File Number	PLSUP-2412-0030		Contact	Jason Mozol, jmozol@duluthmn.gov	
Type	Special Use Permit- Restaurant		Planning Commission Date		May 13, 2025
Deadline for Action	Application Date		April 16, 2025	60 Days	June 15, 2025
	Date Extension Letter Mailed		April 16, 2025	120 Days	August 14, 2025
Location of Subject		421 Anderson Rd			
Applicant	7 Brew		Contact	Kristi Giltner	
Agent	Kimley Horn		Contact	Connor McCoy	
Legal Description		010-2589-00020			
Site Visit Date		April 21, 2025	Sign Notice Date		April 25, 2025
Neighbor Letter Date		April 15, 2025	Number of Letters Sent		40

Applicant proposes to construct a drive-through coffee shop with combined structure footprints of 780 sq ft.

Recommended Action: Approve with conditions.

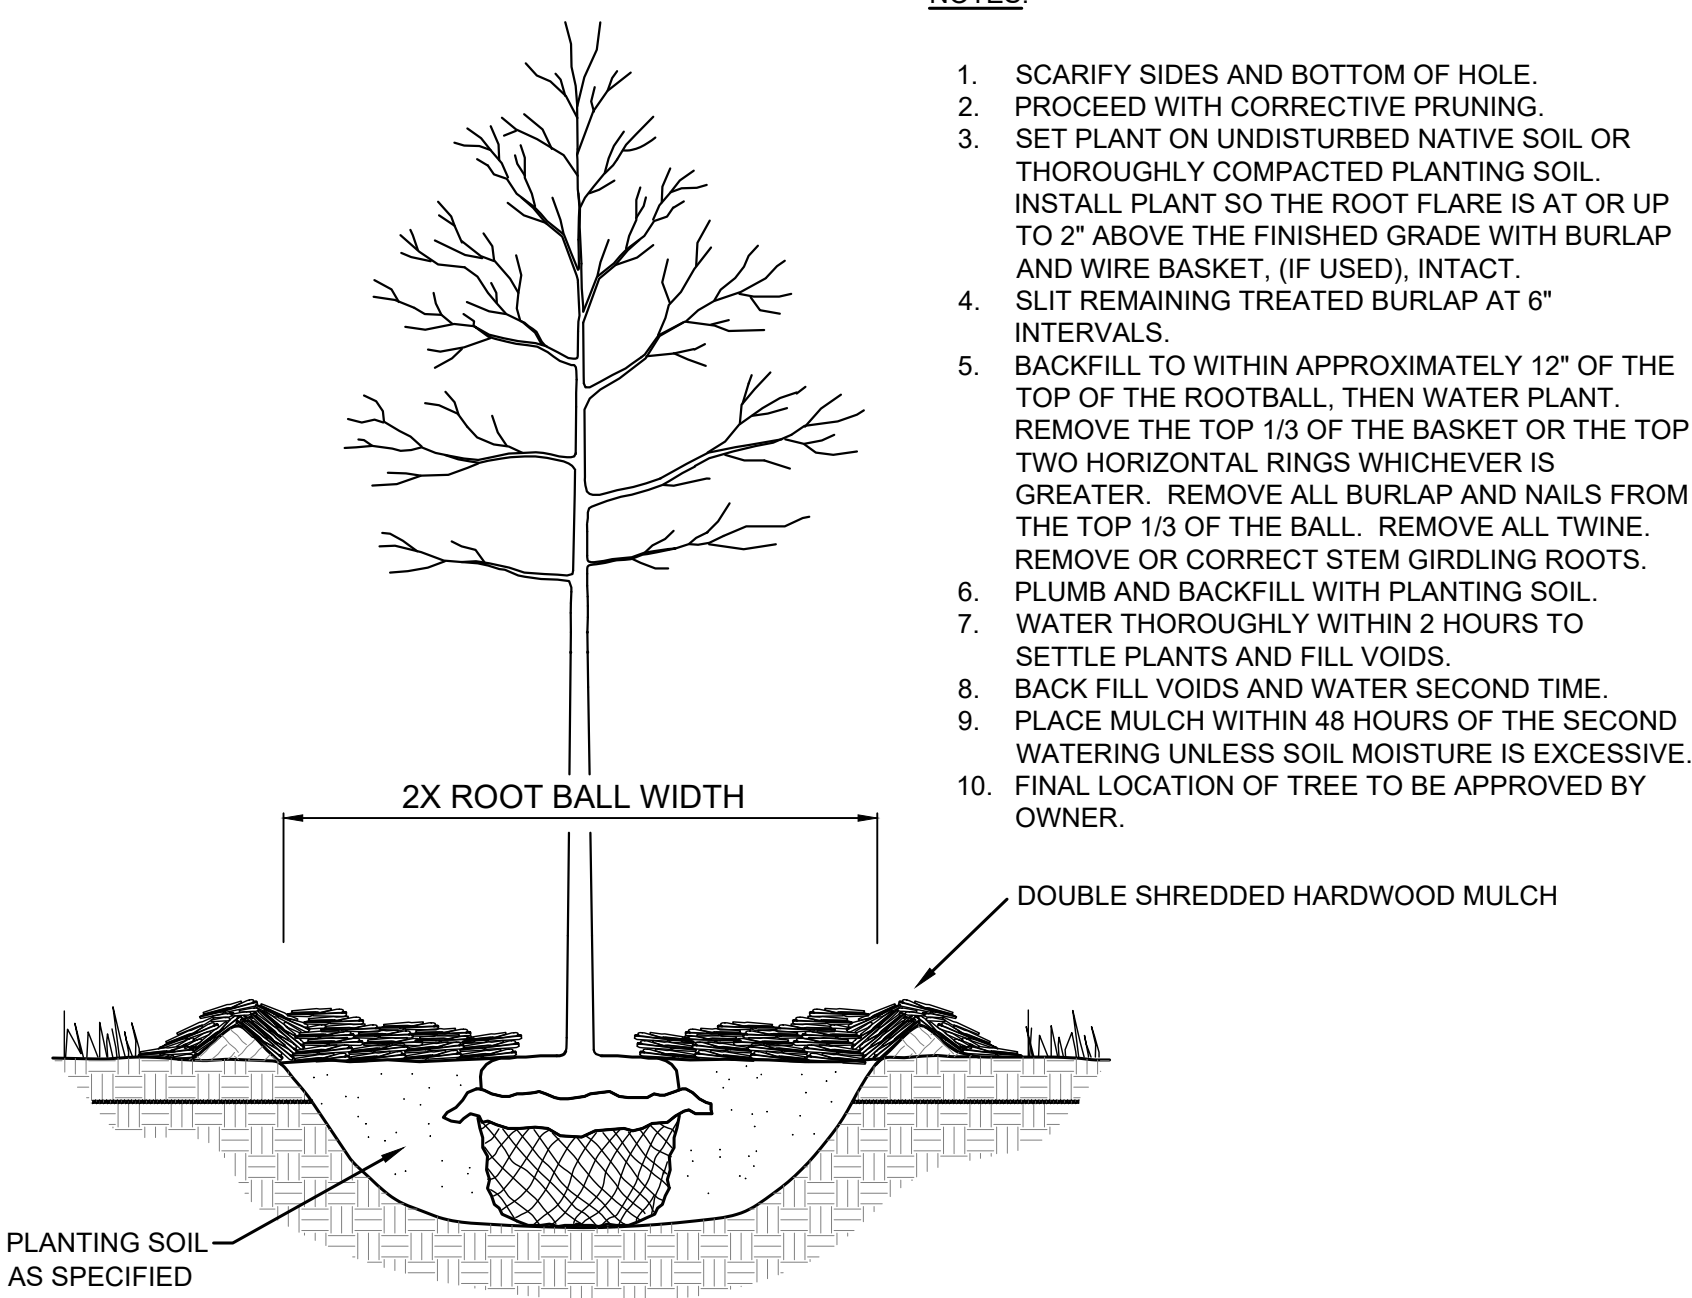
2. UDC Sec. 50-20.3.R (Use-specific Standards).
 - a. The proposed building footprint is below the 5,000 sq/ft maximum.
 - b. Restaurant uses are permitted to have a drive-through in the MU-N district. This drive-through consists of a driving lane and a bypass lane with stacking space for greater than 5 cars.

3. UDC Sec. 50-24 (Parking and loading). The site is proposed to contain 5 off-street parking spaces, one identified as ADA accessible. The project must provide two bike parking spaces that are proposed to be located to the rear of the building.

6. UDC Sec. 50-26 (Screening, Walls and Fences). Trash and recycling containers will be screened by proposed fencing. If any exterior mechanicals are added, these will need to be screened as well.

LANDSCAPE PLAN

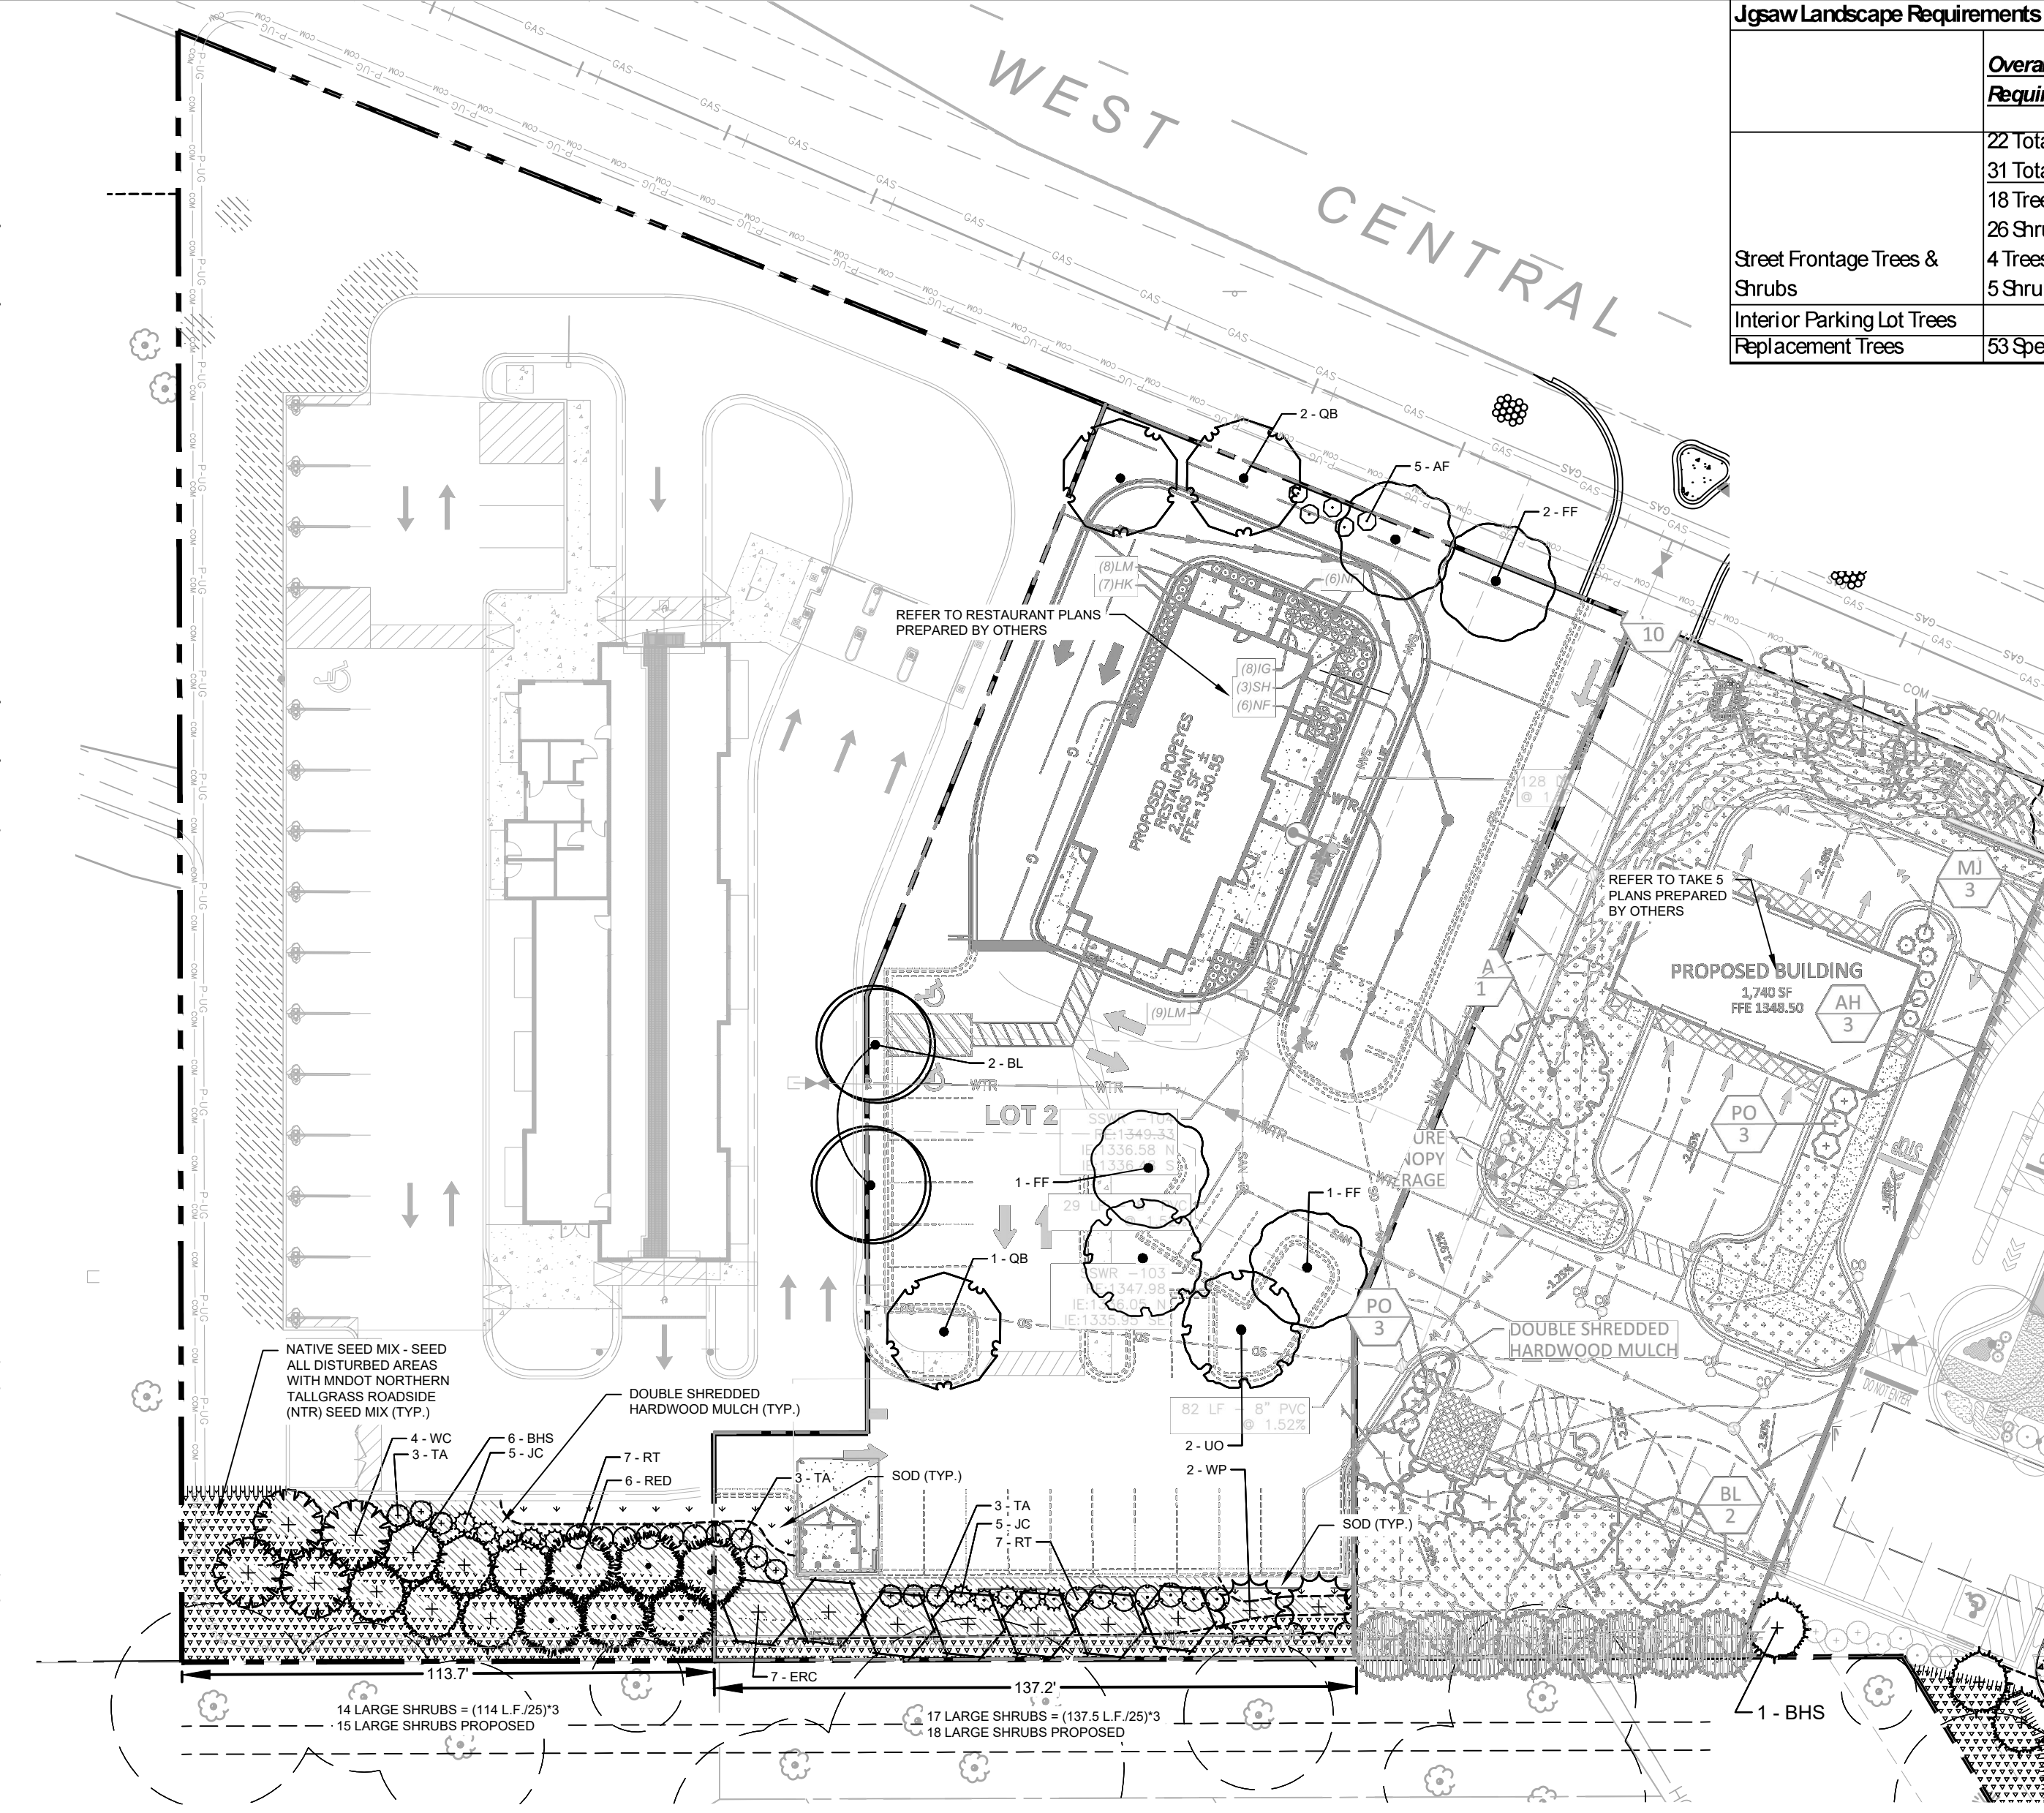
4. UDC Sec. 50-25 (Landscaping and Tree Preservation). Landscaping responsibilities are divided between the overall site developer (Jigsaw LLC) and the applicant (7 Brew). Previous development within the larger Jigsaw Subdivision has resulted in areas of non-compliant landscaping in the rear of the site and along the retaining wall in the front. Two separate landscape plans are attached that, in aggregate, meet minimum landscaping standards for street frontage landscaping, parking lot landscaping, buffering between land uses and tree preservation. The attached landscape plan proposed by Jigsaw LLC remedies the areas of non-compliance and Jigsaw LLC has provided financial security to the City to complete the work.

5. During a recent site visit, staff noted that the site has been poorly managed, (see attached photos), and resulted in trash blowing into the neighbor's yard and gaps where all native vegetation has been cleared. To adequately reduce negative impacts to neighboring properties, staff recommends that a 6' tall, opaque fence is built along the entrance from Anderson Rd and the rear of the property in addition to the proposed vegetative screening.
